## 5.4 Components and Subsystem Design

The information in this section of the reference ABWR DCD, including all subsections, tables and figures, is incorporated by reference with the following departures and supplements.

Figure 5.4-1 Reactor Internal Pump Cross Section

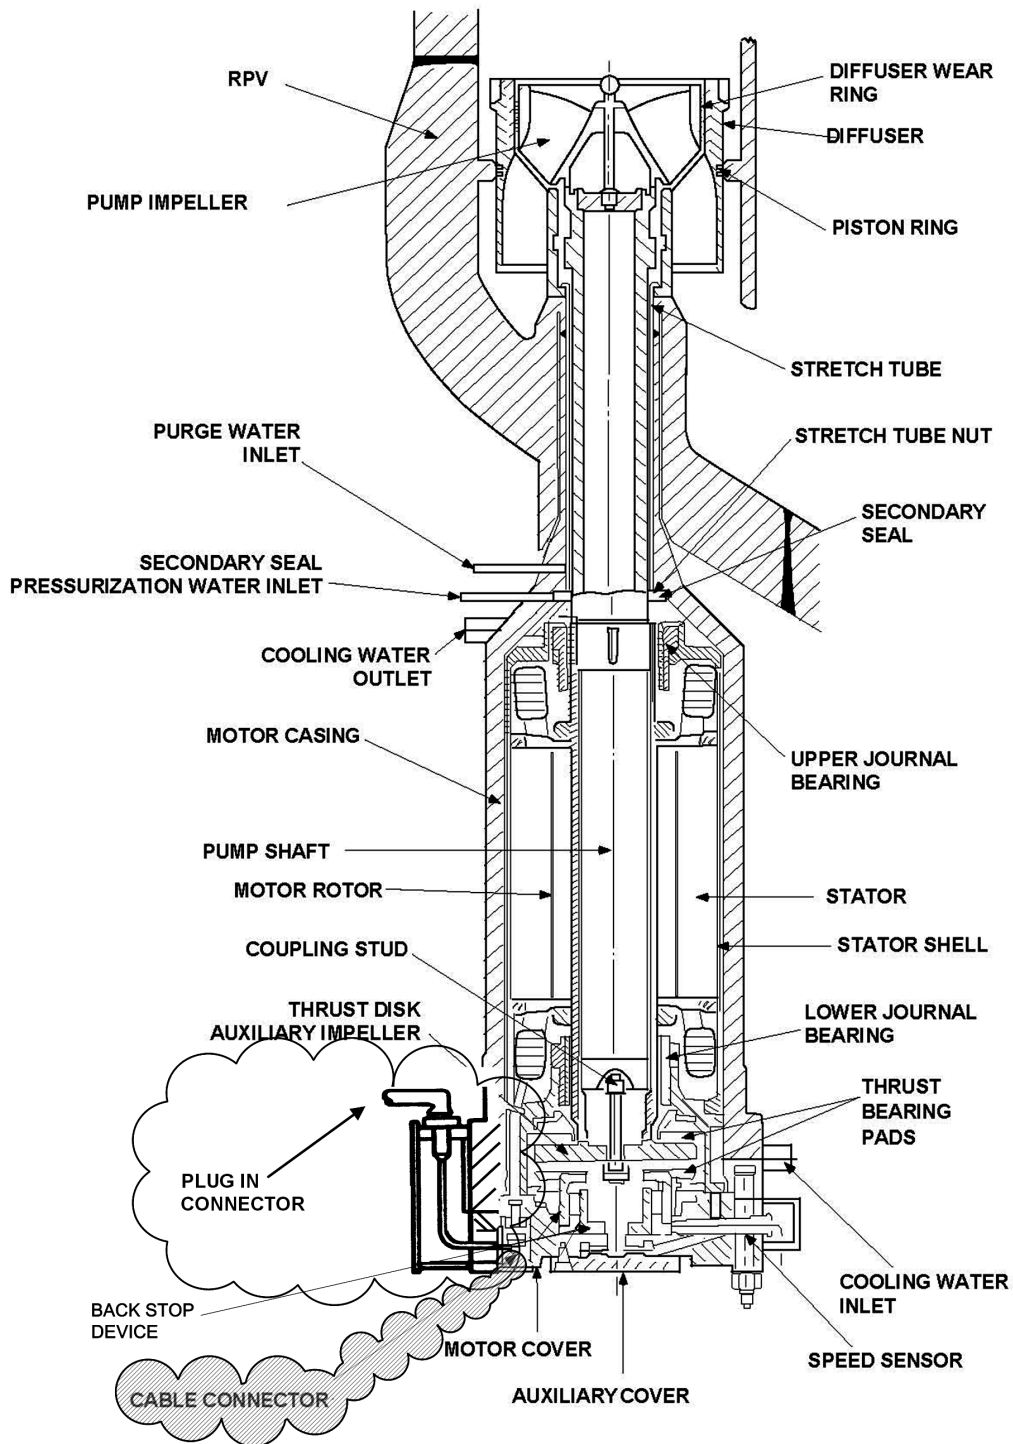
STD DEP 5.4-2 (Figure 5.4-1)
